Our Ref: 17068
Council Ref: SSDA 8517 & SSDA 8449

RE: SSDA 8517 and SSDA 8449 - Response to Request for Further Information

Figure 1 Loading Dock manoeuvring constraints

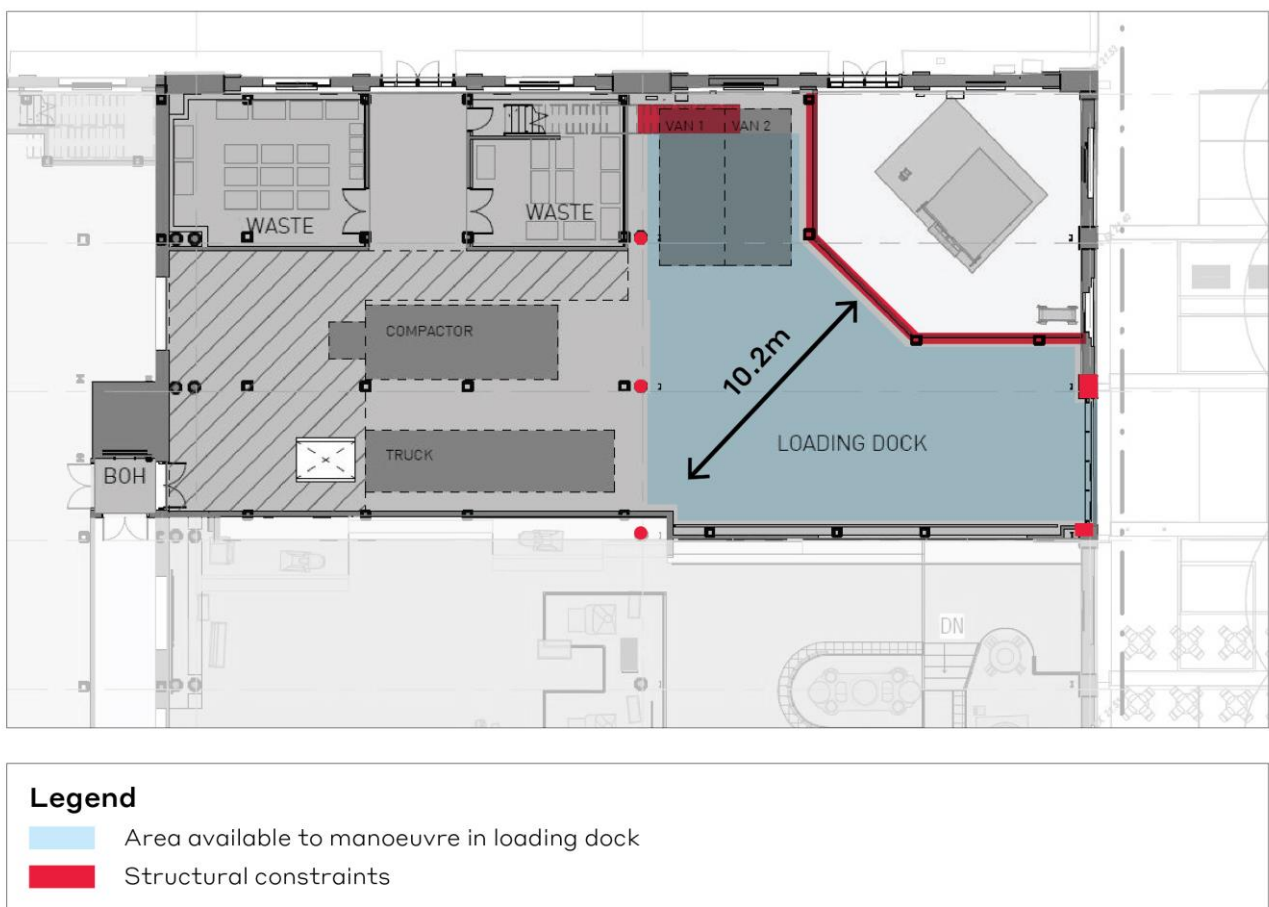
Demonstrate how trucks can enter the loading dock from Innovation Plaza in a forward direction and exit in a forward direction (with all reversing movements occurring within the loading dock).

The proposed design of the loading dock does not allow the proposed 10.2m long trucks to enter and exit the loading dock in a forward direction from Innovation Plaza. The swept path plans submitted with the RTS Report for SSDA 8517 illustrated that service and waste vehicles can exit the loading dock in the forward direction but must reverse to enter from Innovation Plaza.

The analysis has found that the area for manoeuvring vehicles within the loading dock is significantly constrained by the proposed access stairs located adjacent to the northern wall above the van parking spaces; the glass barrier that surrounds and protects the Davy Furnace; the size of the loading dock door and the existing heritage columns, as identified within **Figure 1**. Accordingly swept path assessments have indicated that in order for trucks to complete the three-point turn necessary when entering in a forward gear, the following would occur:

- the 10.15m Large Rigid Truck would conflict with the access stairs above the van spaces, conflict with the Davy Furnace barriers and reverse in very close proximity to the heritage columns. Due to the location of the heritage columns and the loading dock doorway, extending the loading dock wall further south towards the Davy Furnace would not improve the manoeuvrability of the trucks;
- the 10.2m Refuse Collection Truck would need to undertake a 5-point turn and rely on the van parking spaces being unoccupied. Furthermore, there would be a high chance of the trucks colliding with the Davy Furnace barriers, the access stairs above the van spaces and heritage columns. Repositioning of the loading dock wall would also not improve the manoeuvrability of the trucks.

Figure 2 Existing service access route

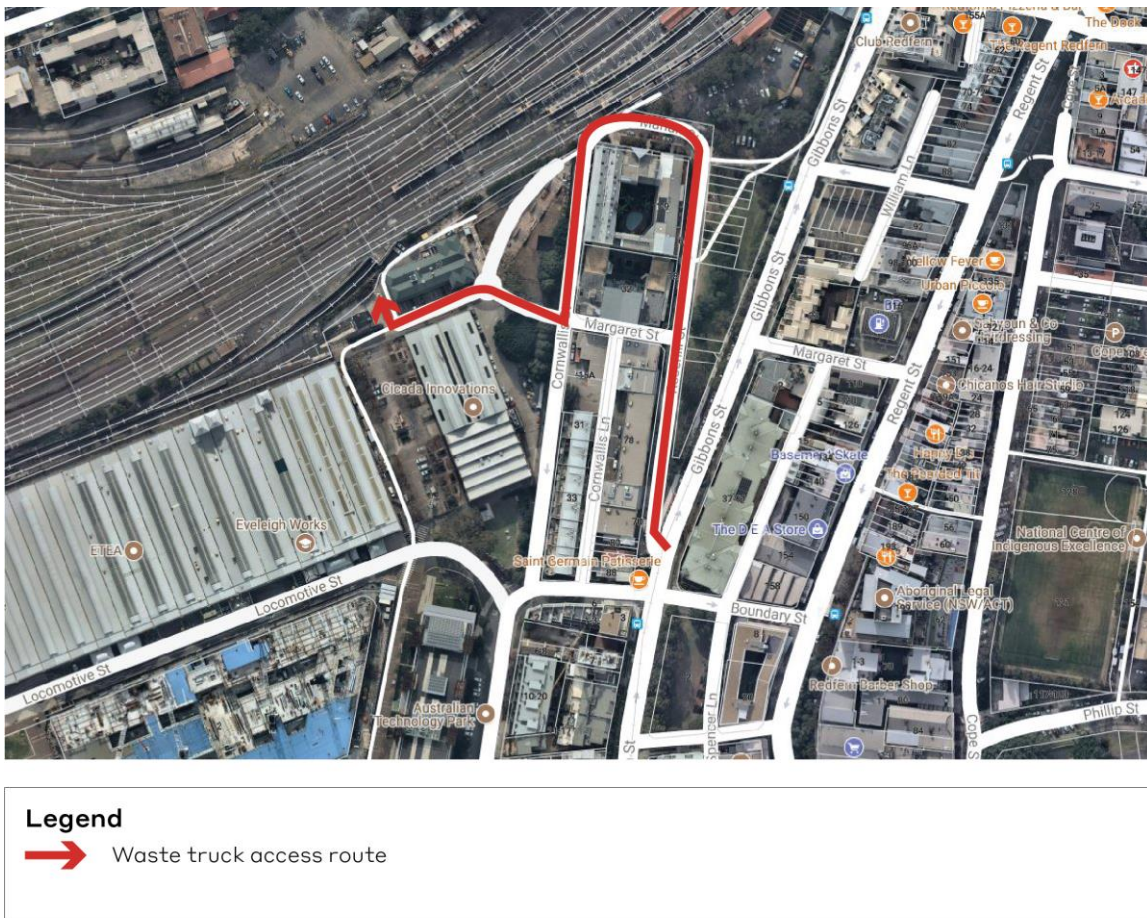
Advise how waste trucks (i.e. route and length of truck) currently access the refuse area located north of Innovation Plaza.

At present, Refuse Collection Trucks that service the Locomotive Workshop have an overall length of 8.0m and service the site 3 times per week. The trucks enter the ATP site from the northern access off Cornwallis Street at the junction with Margaret Street and then drive between the IBA Building and the NIC Building, before turning into Innovation Plaza and reversing to the waste storage compound located to the north of Innovation Plaza and adjacent to the rail line (refer to **Figure 2**). Staff within the Locomotive Workshop transfer their own waste to the waste storage compound.

Figure 3 Proposed extension of the Rosehill Street parking restriction area

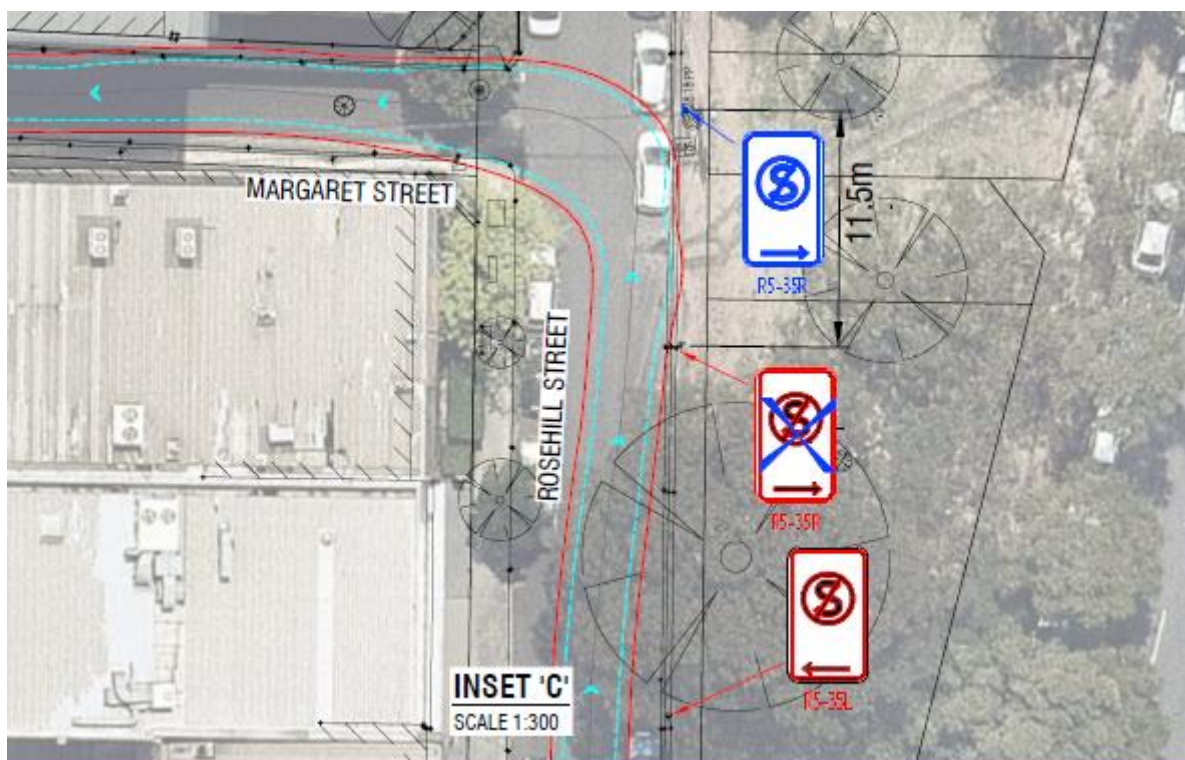
It is the City's preference that the service vehicle travel route should exclude the Shared Zone on Marian Street. If Option 1 via Rosehill Street and Margaret Street is pursued, as stated in previous correspondence, any changes to the existing road network will need to be referred to the Local Pedestrian and Traffic Calming Committee for endorsement and the applicant bears the risk that works may not be endorsed.

Mirvac's preference is to utilise Option 1 – the Rosehill Street- Margaret Street-ATP site and will work with the Local Pedestrian and Traffic Calming Committee to seek endorsement for the 11.5m-12m extension of the current Rosehill Street 'No Stopping' parking restriction near Margaret Street.

To clarify, this extension would only require the relocation of a single signpost and would result in the loss of two on-street car spaces as illustrated in **Figure 3**. No other changes to Rosehill Street or Cornwall Street would be required.

Figure 4 Coach parking bay location plan

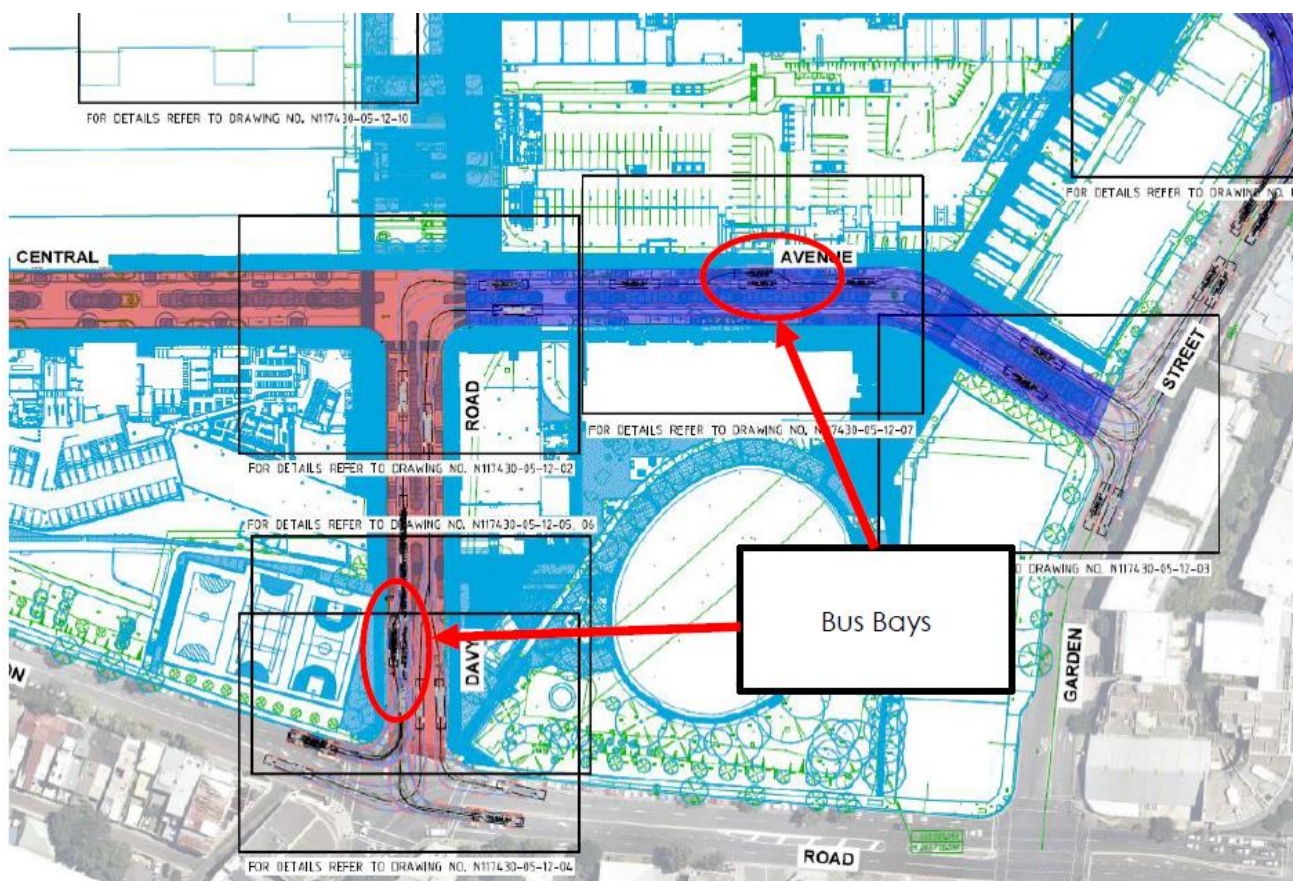
TfNSW requests that the applicant be conditioned to prepare a Coach Parking Management Plan in consultation with the Sydney Coordination Office within TfNSW, prior to the issue of the Construction Certificate.

Details on how vehicles, including coaches, accessing functions can be accommodated within Locomotive Street should be provided. If provision for coaches cannot be accommodated along Locomotive Street, an alternative location along other internal streets within the ATP should be identified, in consultation with the Sydney Coordination Office.

In conjunction with SSDA 7317, it is intended that one permanent coach parking space will be provided on Davy Road West and one temporary coach parking space will be provided on Central Avenue north as illustrated in **Figure 4**. The details of these proposed coach parking spaces have been confirmed within Mirvac's correspondence to TfNSW pursuant to Condition B52 to SSDA 7317.
